Draft amendments to Regulation No. 17

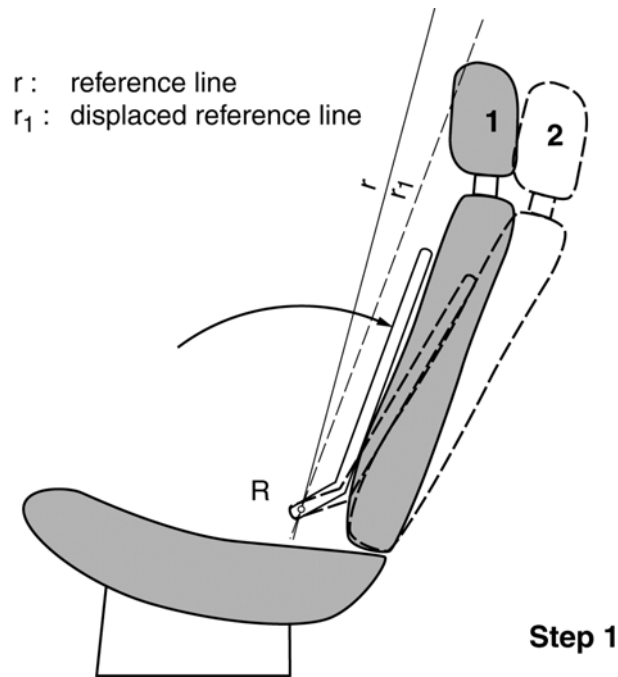
1. Original unloaded position
2. Displaced position by a moment of 37.3 daNm of manikin's back in relation to R point
3. Position after displacement by an initial force F producing a moment of 37.3 daNm about R point
